## Access Compliance Report Public Rights-of-Way (Curb Ramps)

Intersection ID: 4554 Main Street: FLAXSEED\_LN Cross Street: FRANK\_VANCE\_RD Location: NE

ADA ID: EFBCA52A8CD7 Ramp Type: Perp Initial Pass/Fail: Fail Overall Compliance: No Severity Score: 1.25

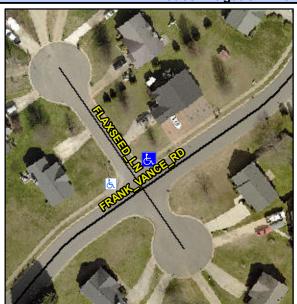
Not Found, R304.5.3

Not Found, R304.5.3

Fleid Measurements/Component Compliance					
Compliance Description			Compliance Description		Data
N/A	Ramp Length (in)	77.0	Yes	Ramp Slope (%)	5.6
Yes	Ramp Width (in)	48.0	No	Ramp XSlope (%)	2.6
N/A	Flare Type LT	N/A	N/A	Flare Type RT	N/A
N/A	Flare Slope LT (%)	N/A	N/A	Flare Slope RT (%)	N/A
N/A	Flare Traversable LT?	N/A	N/A	Flare Traversable RT?	N/A
N/A	Landing Length (in)	N/A	N/A	DWS Provided?	N/A
N/A	Landing Width (in)	N/A	N/A	DWS Contrast?	N/A
N/A	Landing Slope (%)	N/A	N/A	DWS Length (in)	N/A
N/A	Landing X Slope (%)	N/A	N/A	DWS Full Width?	N/A
N/A	Landing Curb? (Y/N)	N/A	N/A	DWS Offset (in)	N/A
N/A	Shared Landing?	N/A			
N/A	Gutter Ponding?	N/A	N/A	Gutter Slope (%)	N/A
N/A	Gutter Lip Ht (in)	N/A	N/A	Gutter X Slope (%)	N/A
N/A	Painted X Walk1?	No	N/A	Painted X Walk2?	N/A
	X Walk 1 Direction	To W		X Walk 2 Direction	N/A
N/A	X Walk 1 Width (in)	N/A	N/A	X Walk 2 Width (in)	N/A
	X Walk 1 Slope (%)	1.4		X Walk 2 Slope (%)	N/A

Remove & Replace Entire Ramp.
